The Commission has issued the enclosed Amendment No. 17 to Facility Operating License No. DPR-23 for the H. B. Robinson Steam Electric Plant Unit No. 2. This amendment consists of changes to the Technical Specifications in response to your request dated November 6, 1975.

H. B. ROBINSON STEAM ELECTRIC PLANT UNIT NO. 2

AMENDMENT TO FACILITY OPERATING LICENSE

Amendment No. 17  
License No. DPR-23

Figure 6.2-1

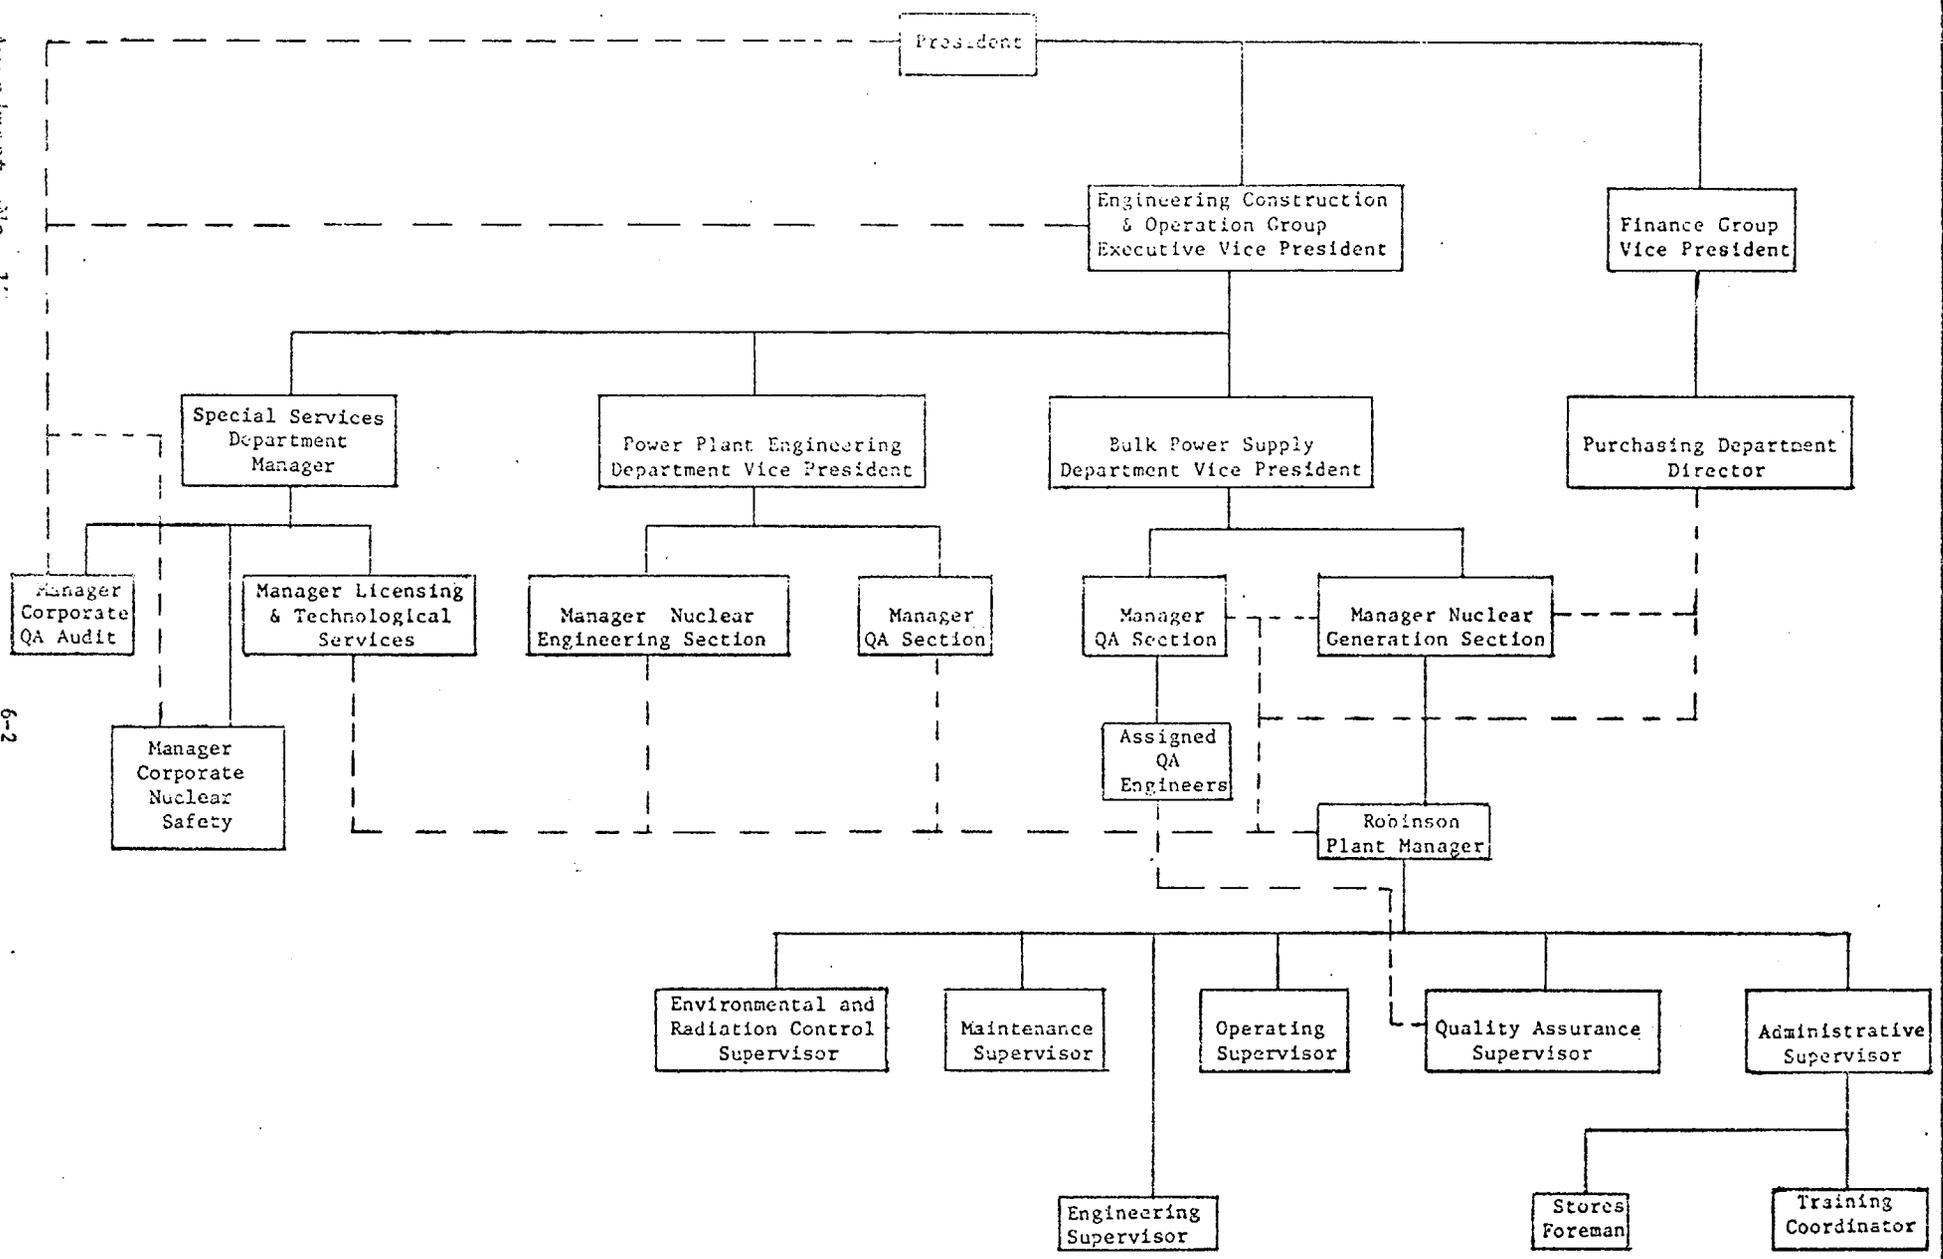
6.2.1 The offsite organization for facility management and technical support shall be as shown on Figure 6.2-1.

Figure 6.2-2

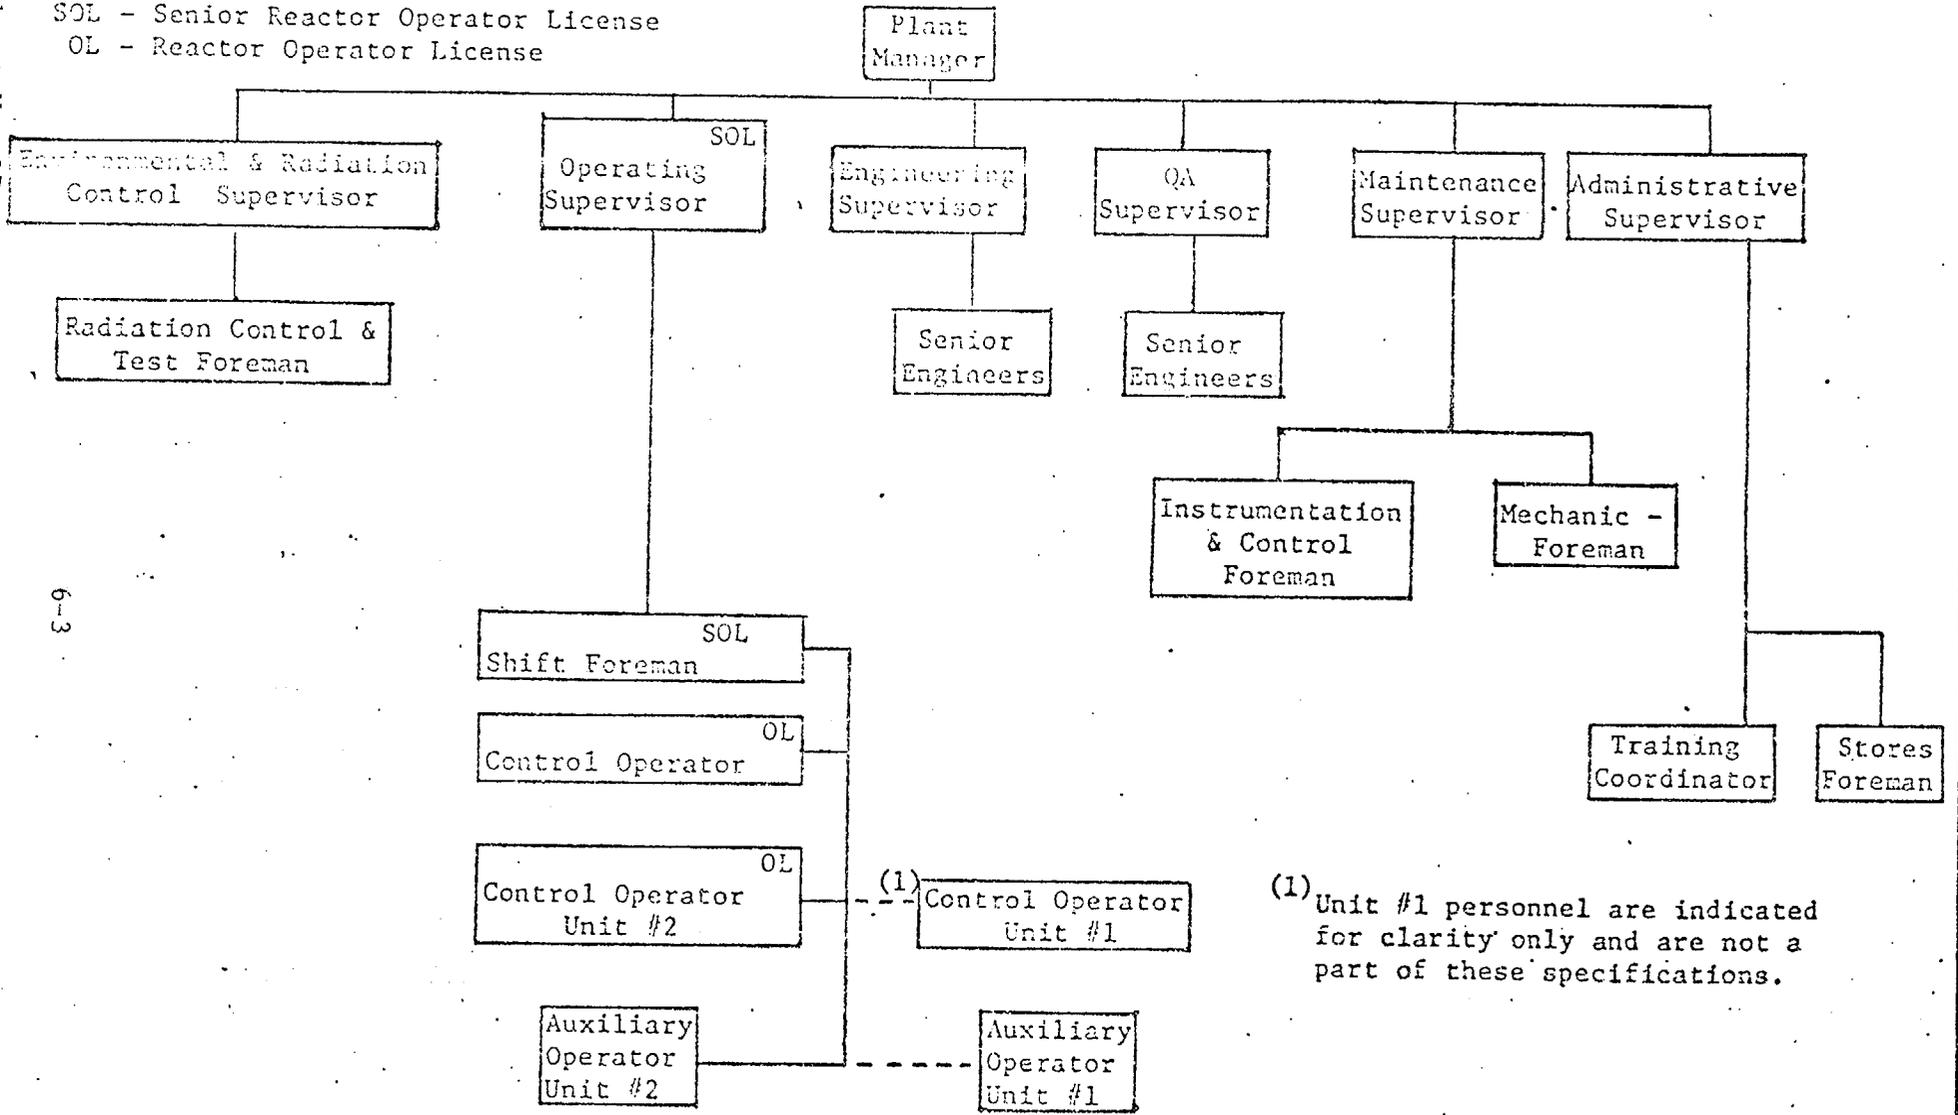
6.2.2 The facility organization shall be as shown on Figure 6.2-2 and:
